Addendum No. 002

Subject: New Solomon Solis-Cohen Elementary School

SDP Contracts No. B-075C, B-076C, B-077C and B-078C of 2017/18

This Addendum, dated July 19, 2018, shall modify and become part of the Contract Documents for the work of this project. Any items not mentioned herein, or affected by, shall be performed strictly in accordance with the original documents.

SITE PHASING PLAN- PHASE 1 AND 2

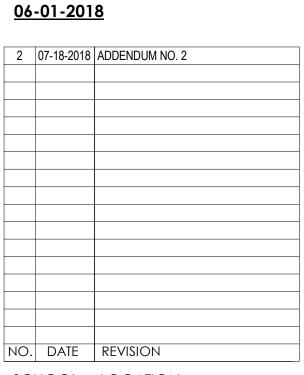
- Q 1.3 Confirm that no emergency exits into phase 1 construction site will be required for the occupied wings D, F & H during Phase 1.
- **A.** Yes. Emergency egress is required from the occupied wings D,F and H out of the construction site during Phase <u>1</u>. Attached to this addendum is the revised Drawing PH.1 showing the emergency path of travel.
- Q. 1.4 Confirm there are no discounts or bidding advantages for GC's in Phila vs. Non Phila GC's.
